TG5/SAR Meeting

DREAM: Overview of NCR and NIT's @17/03/26

DREAM: Status of NCR

DREAM: Status of NIT's

NCR 10635:

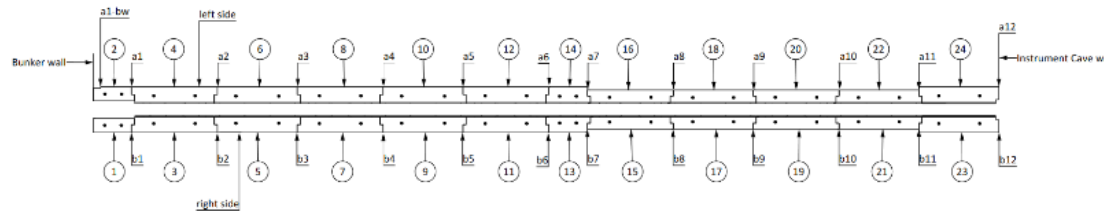
Oversized gaps in the DREAM Guide Shielding (23 on 292)

Reported in *ESS-5796752 DREAM Guide Shielding - Gap Measurement sheet*

Reported in *ESS-5796751 SAT DREAM Guide Shielding*

→ RP will measure in the area once the instrument is operational and decide if more shielding is needed

NIT-673 and NIT-674: Live data display of DREAM detectors - HR and SANS, Sumo and mantel

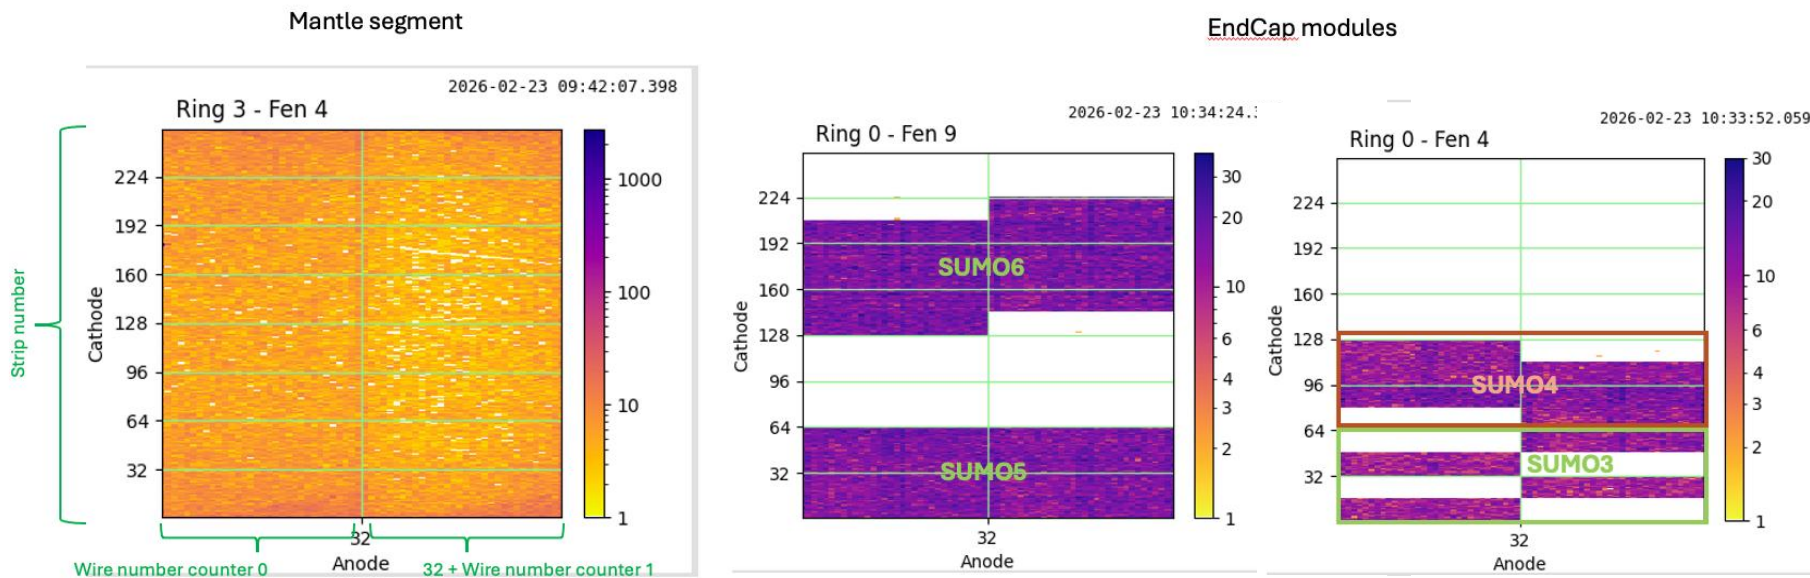
Instrument needs logical representation to allow maintenance and debugging

DREAM - SAR

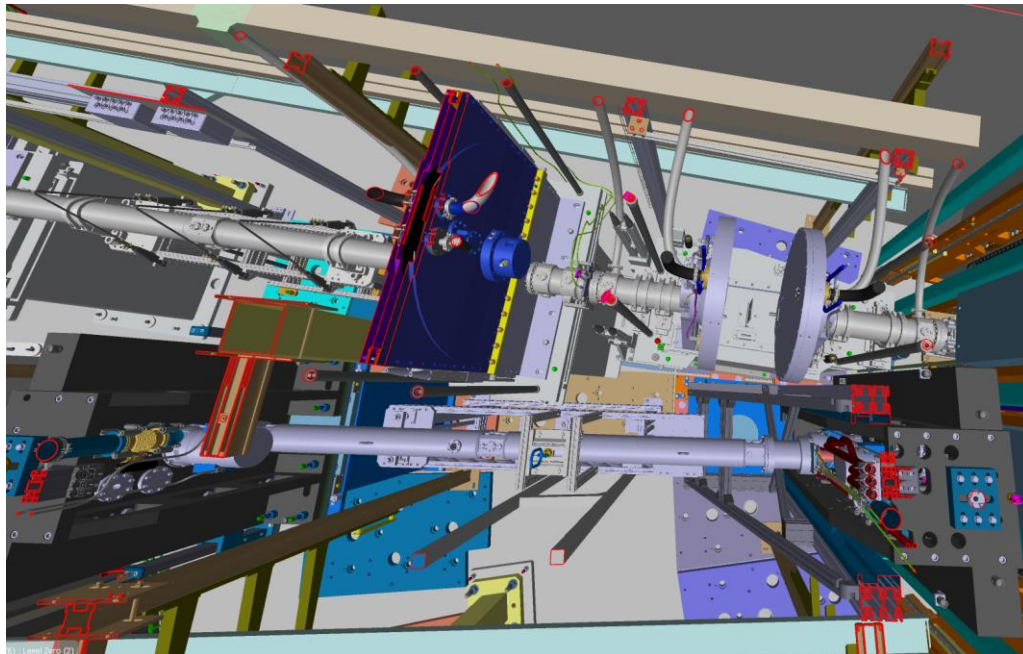
Uneven gaps in the DREAM Cave roof

Reported in *ESS-5878375 – DREAM - Shielding SAT*

Reported in *ESS-5993146 - DREAM - Cave Shielding gaps*

→ Gaps can fulfil the requirements when they are evenly installed

→ RP will measure once the instrument is operational
